4817 Dorset Avenue (Prelim.) 3 P
(Somerset Historic District)

HISTORIC PRESERVATION COMMISSION STAFF REPORT

Address: 4817 Dorset Avenue Meeting Date: 02/28/01
 Applicant: Rodd & Jodi Macklin Report Date: 02/21/01
 (David Jones Architects)
 Resource: Somerset Historic District Public Notice: 02/14/01
 Review: HAWP Tax Credit: Partial
 Case Number: 35/36-01B Staff: Perry Kephart Kapsch

PROPOSAL: New garage, rear/front/side additions, tree removal, new cladding.

Martha Webster • Front Elevation Study • David & Iris Architects
Proposed 2/28/01

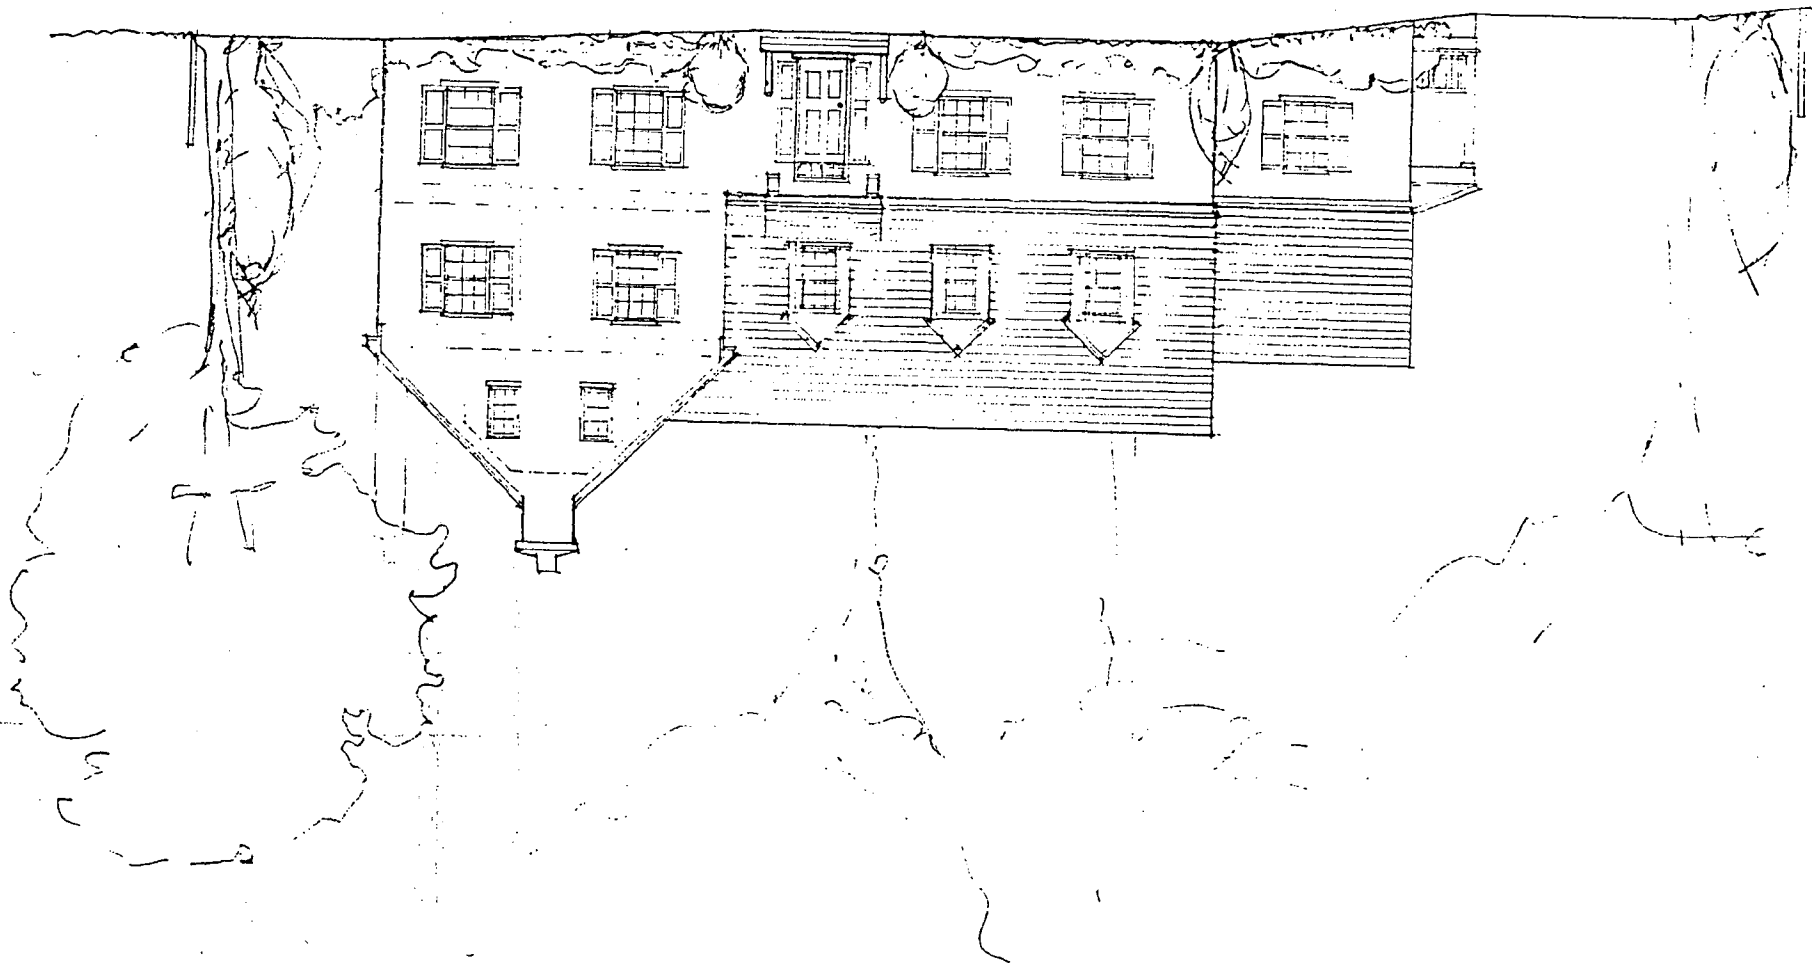
1. Re-locate the 2-story wing back 2' to align with the existing house.
2. Delete the front porch, substituting a roof overhang and stoop at the front door.
3. Apply stucco over the existing stone and brick, with the new additions sheathed in stucco over masonry.

I have attached a drawing of the front elevation illustrating those changes for your consideration.

1. Delete the stucco covering on the existing stone front facades.
2. Offset the new 2 1/2 -story wing back or forward several inches from the existing front façade.
3. Document and photograph the existing conditions, particularly the front entrance, before construction commences. The records are to be retained in the HPC files for the Somerset Historic District. *+ interior*

Mackin Residence - Front Elevation Study - David James Aichels

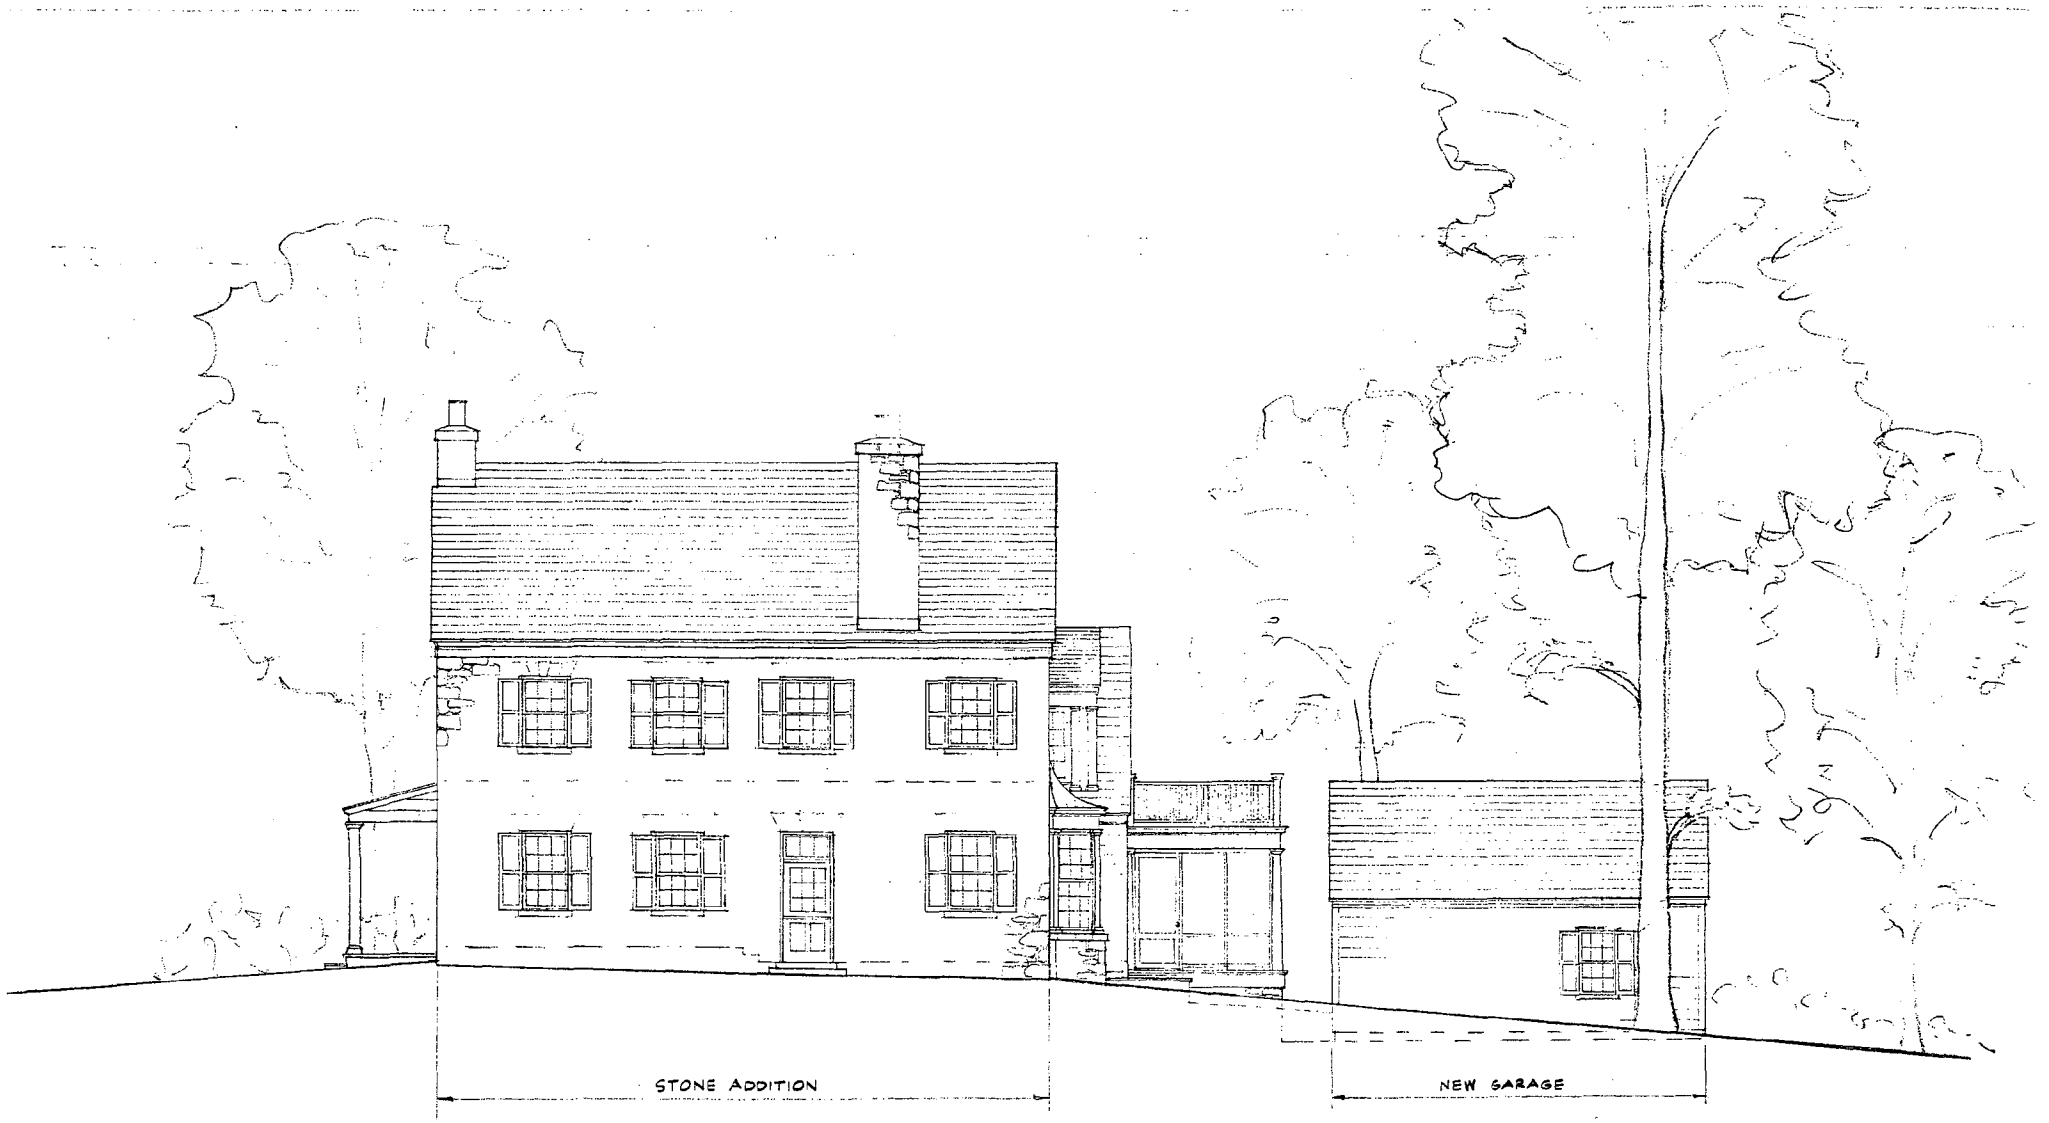
1. Re-locate the 2-story wing back 2' to align with the existing house.
2. Delete the front porch, substituting a roof overhang and stoop at the front door.
3. Apply stucco over the existing stone and brick, with the new additions sheathed in stucco over masonry.

I have attached a drawing of the front elevation illustrating those changes for your consideration.

1. Delete the stucco covering on the existing stone front facades.
2. Offset the new 2 ½ -story wing back or forward several inches from the existing front façade.
3. Document and photograph the existing conditions, particularly the front entrance, before construction commences. The records are to be retained in the HPC files for the Somerset Historic District.
